Access Compliance Report

Public Rights-of-Way

(Curb Ramps)

Intersection ID: 10033675	Main Street: ORCHARD_LAKE_DR	Cross Street: N/A	Location:	N
ADA ID: 01AB086AE AFC	Ramp Type: BlendTrans1	Initial Pass/Fail: Fail	Overall Compliance: No	Severity Score: 1.25
Codes/Mitigation Info/Possible Solution		Field Measurements/Component Compliance

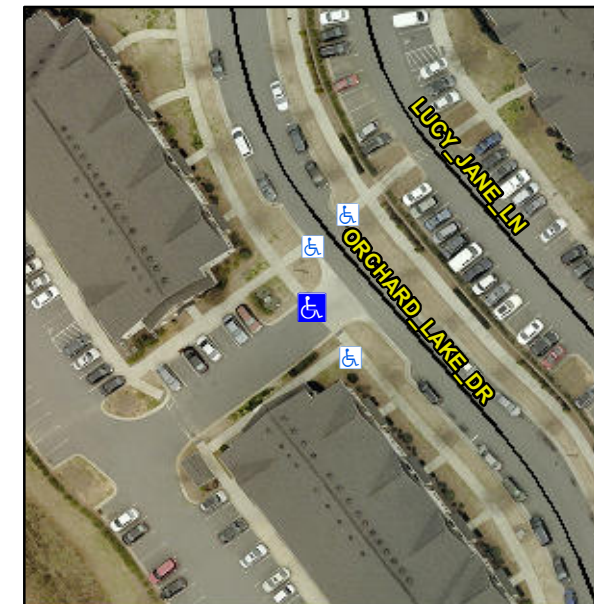
R304.5.3

Compliance	Description	Data	Compliance	Description	Data
N/A	Ramp Length (in)	72.0	Yes	BlendTrans Slope (%)	1.2
Yes	Ramp Width (in)	72.0	No	BlendTrans XSlope (%)	2.3
N/A	Flare Type LT	N/A	N/A	Flare Type RT	N/A
N/A	Flare Slope LT (%)	N/A	N/A	Flare Slope RT (%)	N/A
N/A	Flare Traversable LT?	N/A	N/A	Flare Traversable RT?	N/A
N/A	Landing Length (in)	N/A	N/A	DWS Provided?	N/A
N/A	Landing Width (in)	N/A	N/A	DWS Contrast?	N/A
N/A	Landing Slope (%)	N/A	N/A	DWS Length (in)	N/A
N/A	Landing X Slope (%)	N/A	N/A	DWS Full Width?	N/A
N/A	Landing Curb? (Y/N)	N/A	N/A	DWS Offset (in)	N/A
N/A	Shared Landing?	N/A			
N/A	Gutter Ponding?	N/A	N/A	Gutter Slope (%)	N/A
N/A	Gutter Lip Ht (in)	N/A	N/A	Gutter X Slope (%)	N/A
N/A	Painted X Walk1?	No	N/A	Painted X Walk2?	N/A
	X Walk 1 Direction	To SE		X Walk 2 Direction	N/A
	X Walk 1 Width (in)	N/A		X Walk 2 Width (in)	N/A
	X Walk 1 Slope (%)	1.8		X Walk 2 Slope (%)	N/A
	X Walk 1 X Slope (%)	1.1		X Walk 2 X Slope (%)	N/A

Remove & Replace Curb Ramp With Two New Directional Ramps or Equivalent.
